## **MAJOR PROJECT ASSESSMENT:**

### ***Water and Wastewater Servicing West Dapto Urban Release Area and Adjacent Growth Areas***

***(MP09\_0189)***

Director-General's  
Environmental Assessment Report  
Section 75I of the  
*Environmental Planning and Assessment Act 1979*

**Figure 4:** Avondale Reservoir Site

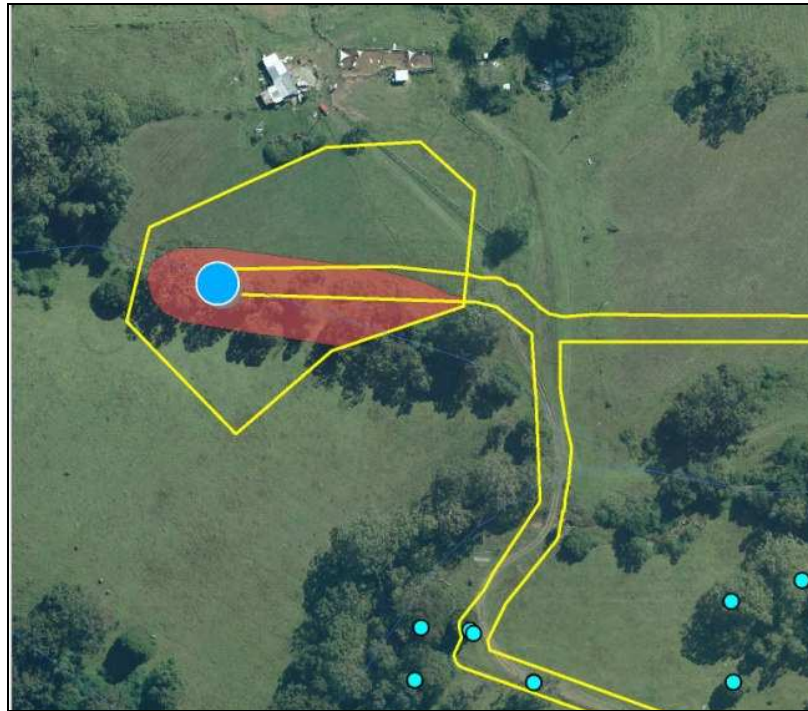
Up to 0.34 hectares of Illawarra Lowland Grassy Woodland and 3 hollow bearing trees would be cleared for the construction of reservoirs at Avondale. The EA indicates that the reservoir at Avondale could be located within the existing cleared area (refer **Figure 4**) and therefore impacts to extant vegetation could be avoided.

The Department agrees that this impact is not significant and that measures such as further refinement to avoid native vegetation and installation of nest boxes are appropriate. The Department recommends that a landscaping and rehabilitation management plan be prepared for all reservoirs sites. This plan is to include measures for rehabilitation which take into account the existing vegetation both on and surrounding the site as well as attributes that would encourage its use by native fauna from the surrounding area.
